<b>Technical Information</b>	Date: 26.05.2015 Official: Marier Department.: ST-FIR/MKP3
------------------------------	--

<b>Tech. Information No.</b>	1924 / 2015
<b>Subject:</b>	The relays of the FLM-420-RLV8-S cannot be activated

<b>Short Description:</b>	Bending the FLM-420-RLV8-S can damage the PCBA. Test the relays during commissioning and maintenance.
---------------------------	--

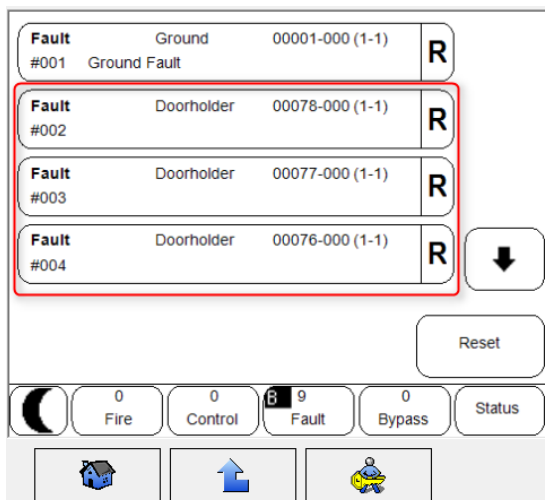
A broken resistor on the PCBA of the FLM-420-RLV8-S leads to the malfunction of the relays.

The breakdown of the resistor is caused by bending the PCBA.

Because the PCBA can bend during installation, it's recommended to test each single relay output during the commissioning phase or maintenance check.

- Assign an address to all eight relay outputs and select usage type "door holder" with standby mode ON (default)
- Upon re-configuration and system re-boot all eight "door holder" outputs of a faulty FLM-420-RLV8 will be displayed in FAULT.

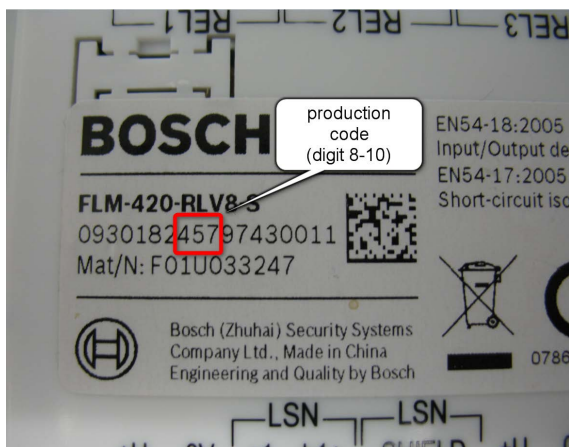
In order to eliminate the root cause of the failure, our engineers optimized the plastic housing. This will prevent to bend the PCBA when it's exposed to mean pressure.

\* The optimized housing can be identified through the production code, starting with production code '519' (March 2015).
